**Proposal for a global technical regulation on
the Worldwide harmonized Light vehicles Test Procedure**

Corrigendum to the proposal for a new global technical regulation on the Worldwide harmonized Light vehicles Test Procedure (WLTP)

Submitted by the Secretariat

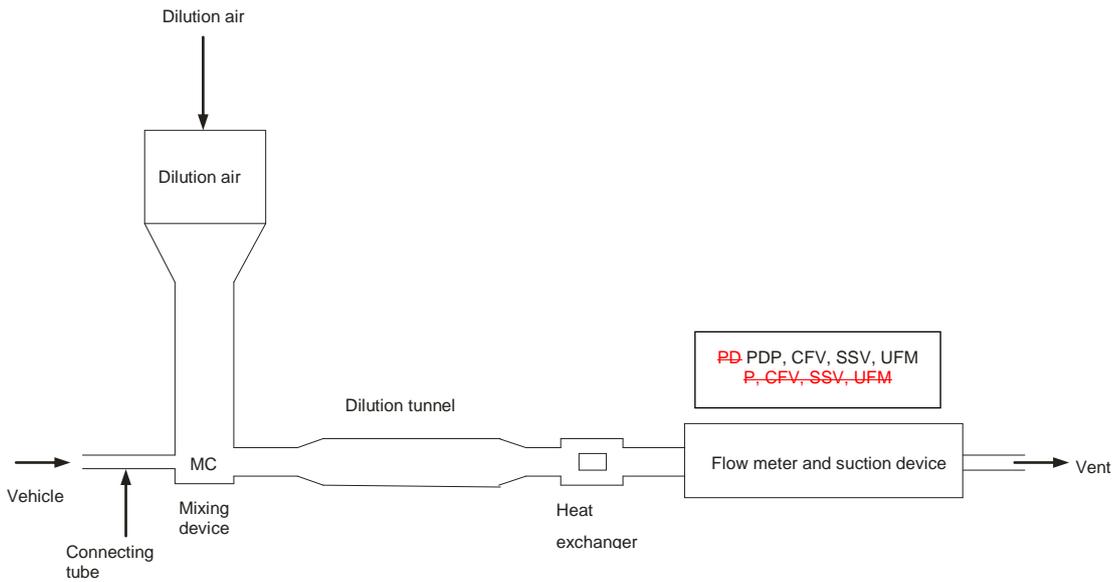
Page 119, letter b) of paragraph 1.1.2. of Annex 5, correct read:

(b) For circular fan outlets, the outlet shall be divided into 8 equal sections by vertical, horizontal and 45° lines. The measurement points lie on the radial centre line of each arc (22.5°) at two thirds of the outlet radius (as shown in Figure A5/2).
